17 & 19 SERIES SERVICE ENGINEERS

Subject: 19DG MOTOR COOLING PROBLEM

FIELD EXPERIENCE REPORT 74-3 REVISION
Supersedes FER 74-3 dated 6/5/74

Fig. 1

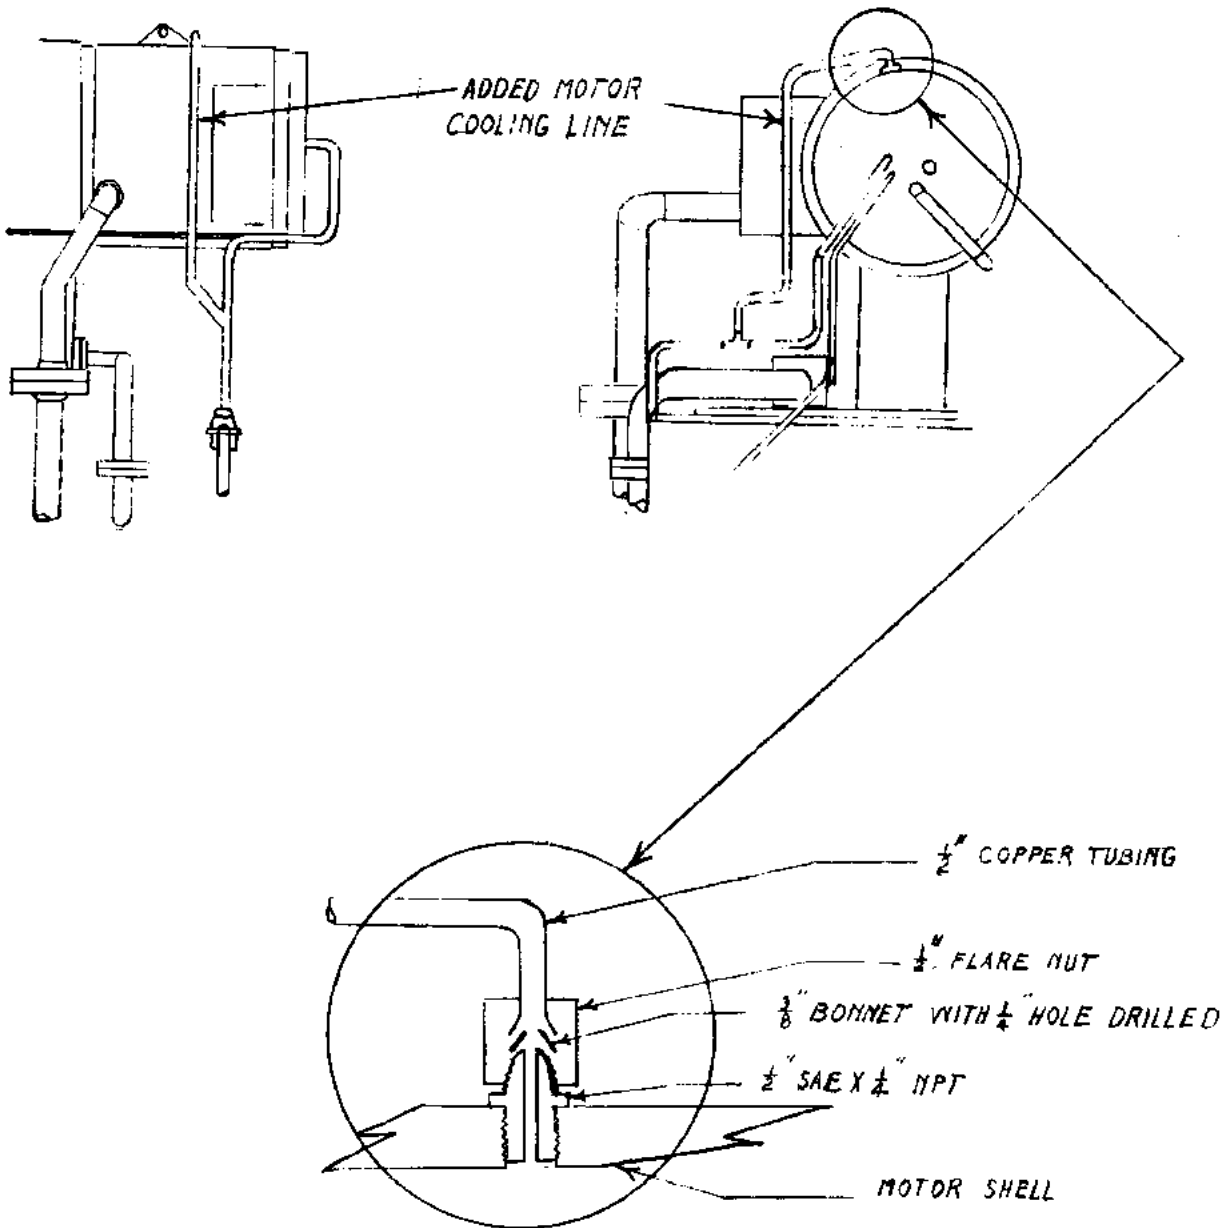
Some larger 19DG machines have been experiencing nuisance tripouts due to motor over temperature. Engineering tests on these motors have prompted a factory modification to all C8 - C10 motors. This modification is the addition of another spray on top of the motor shell. (See figure 1.) This change is effective as of November 1974. If a 19DG machine is experiencing nuisance tripouts due to motor over temperature, it is recommended the following checks be made in addition to the installation of the factory fix:

Install a 1/2" line from the refrigerant supply line, after the filter, to the top of the motor shell. The 1/4" M.P.T. plugged hole on the terminal side of the shell will be utilized for additional cooling. The refrigerant should be metered through a 1/4" orifice (figure 1).

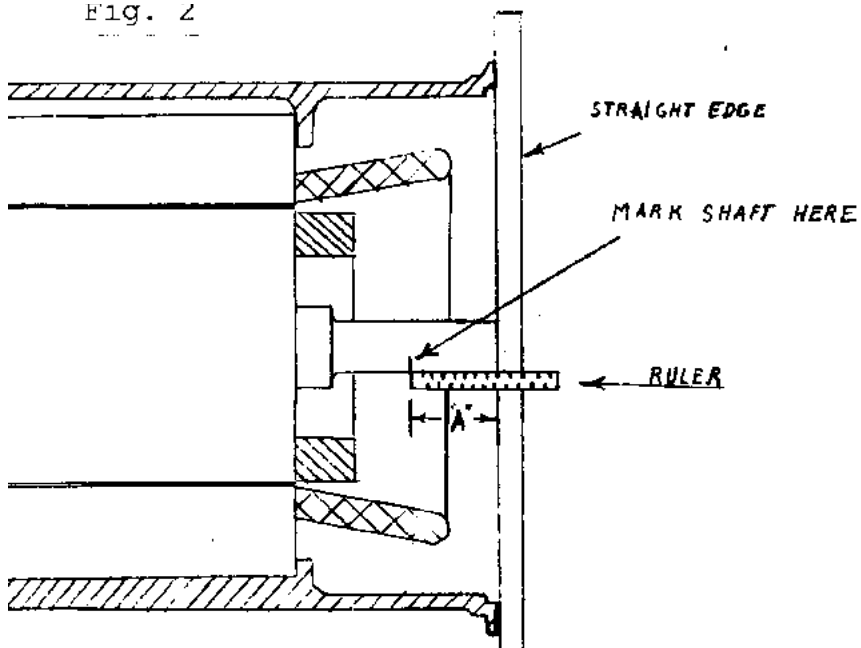
2. Lay the straight edge across the motor shell. Using a ruler, measure inward toward the rotor distance "A," and mark the shaft with a felt tip pen (figure 2).

Fig. 3

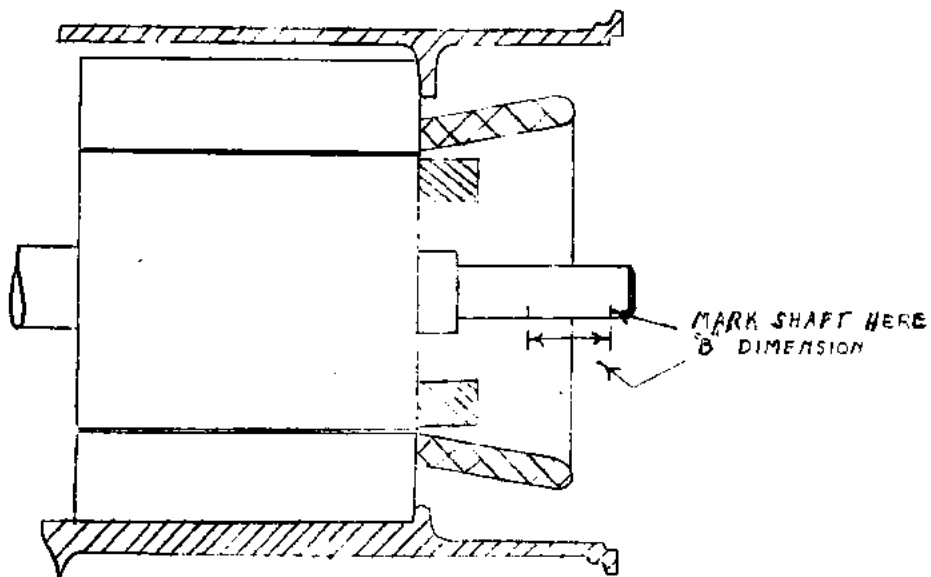
3. Measure the distance "B" on the bell end bearing (figure 5).
4. From the mark on the shaft (step 2), measure outwards the distance "B" and make a second mark on the shaft (figure 3).

Fig. 4

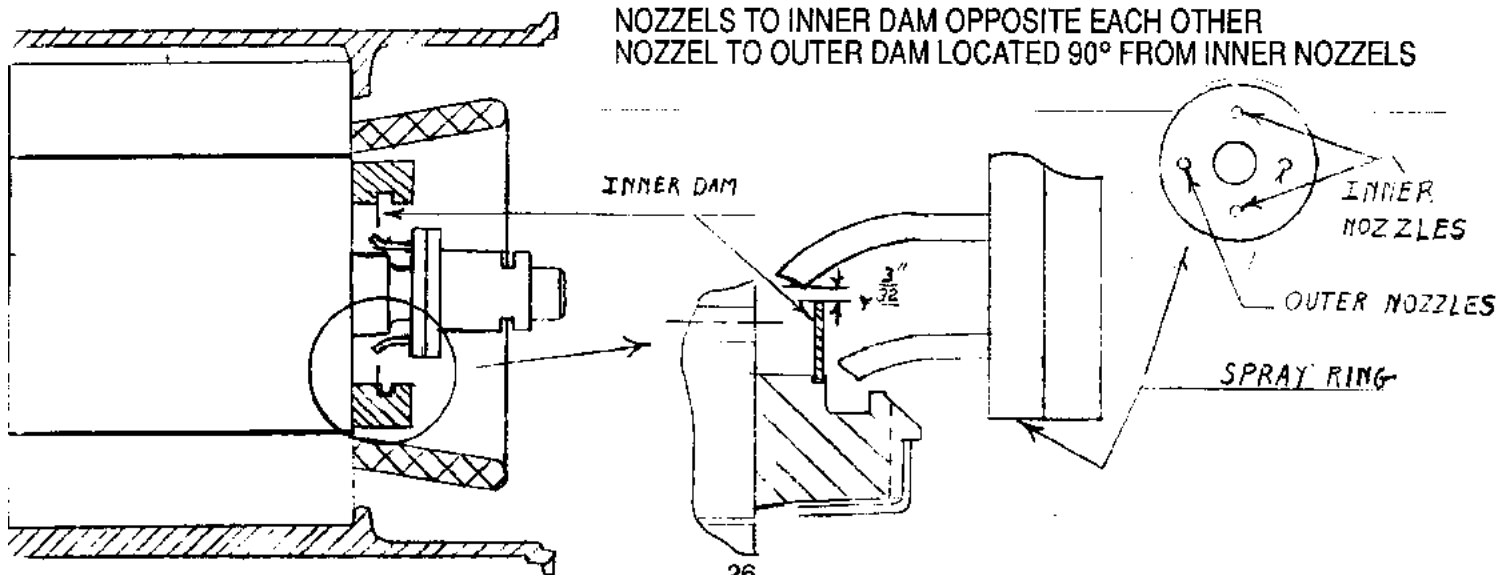
5. Hold the spray ring against the bell end bearing and slide the assembly over the shaft until the second mark just appears at the end of the bearing. The nozzles and bearing are now in the running position (figure 4).

6. Visually check to be sure the discharge area of the two longer nozzles is totally behind the inner dam, and the shorter nozzles are directed into the outer dam. Adjust nozzles as necessary (figure 4).

Fig. 6

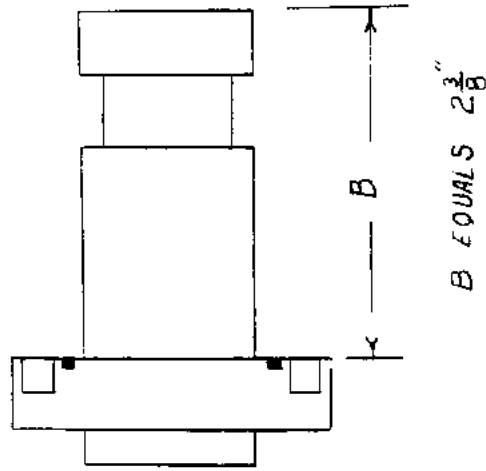
1. Measure the distance from the surface on the end bell that mates to the motor shell, to the surface that the bell end bearing bolts to (figure 6). Use a straight edge and a ruler recording this as dimension "A."
